**Pueblo - Pinon Rest Area NB - I-25 MM 114.99**  
**Elevation  $\approx$  4900'**

## **Summary Observations**

**Replace worn out sign**

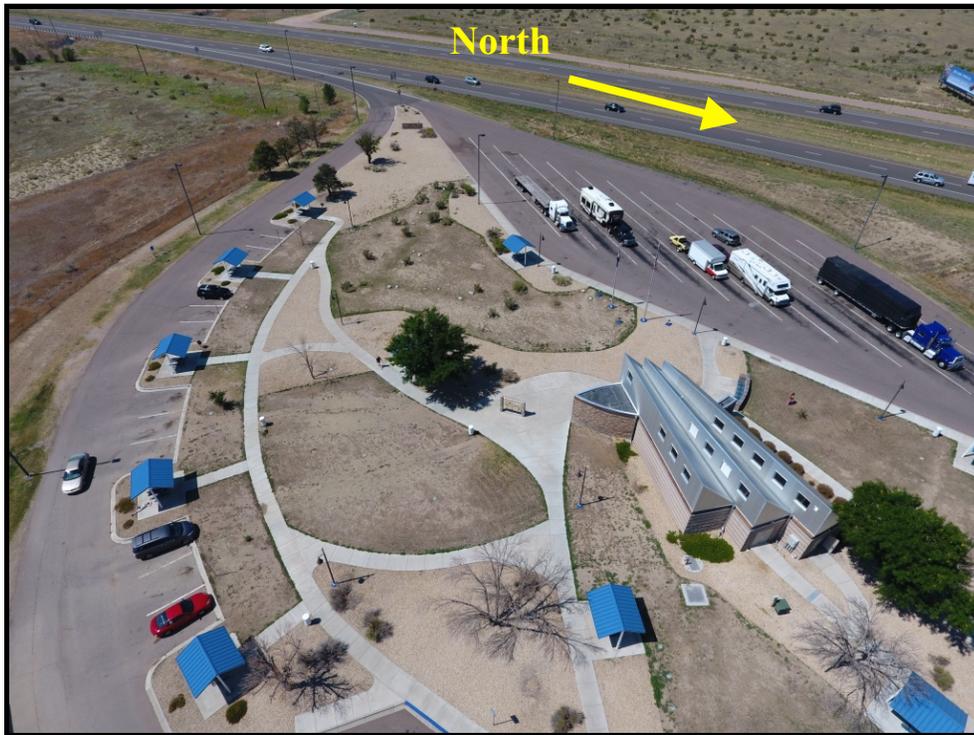
The minor corrections needed include a restroom sign on the wall on the latch side of door for the 'family' restroom and replacing the worn out sign at the men's restroom. The women's rest room has six stalls, with one full size accessible toilet stall. With six or more stalls there should also be an ambulatory stall. This may be accomplished by just adding grab bars on each side of a regular stall, ideally next to the ADA accessible stall.
